United States Department of the Interior

ER-13/0137

The Department of the Interior (Department) has reviewed the Department of State's Draft Supplemental Environmental Impact Statement (DSEIS) for the Keystone XL Pipeline Presidential Permit. The Department offers the following comments and recommendations for your consideration.

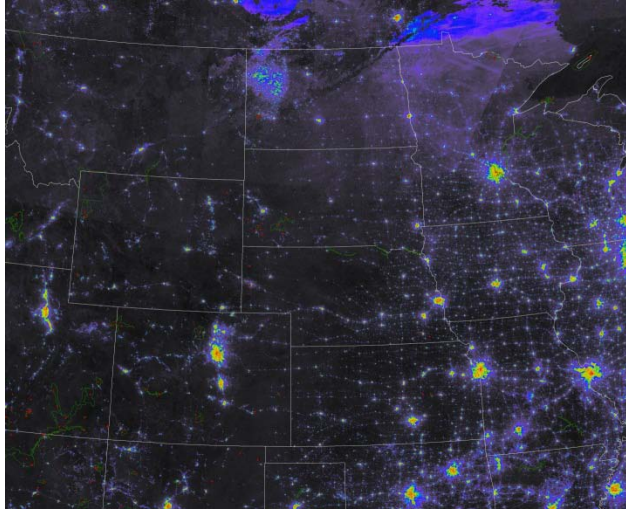
Lighting needs, lighting types, light pollution and lighting impacts are not adequately addressed in the document. Site plans for aboveground installations (from previous planning documents) do not include lighting schematics. Further information and analysis regarding lighting along the pipeline and in the vicinity of national trails and the Niobrara NSR is recommended in order to assess the impacts to park resources.

This 2012 NASA Earth Observatory image of the central United States shows light sources in the central plains. Much of the proposed pipeline route has little anthropogenic light and, therefore, has high quality night skies. The cumulative effects of the project could adversely impact the quality of the night skies and the overall photic environment.

The Department recommends that: additional analysis of the direct and cumulative effects from lighting in this project be conducted; aboveground facilities be located as far away from park units as is feasible; mitigation measures such as shielded, full-cutoff

lighting, timers, and motion sensitive switches should be used, where possible; and the minimum amount of illumination be used for tasks commonly carried out along the pipeline.
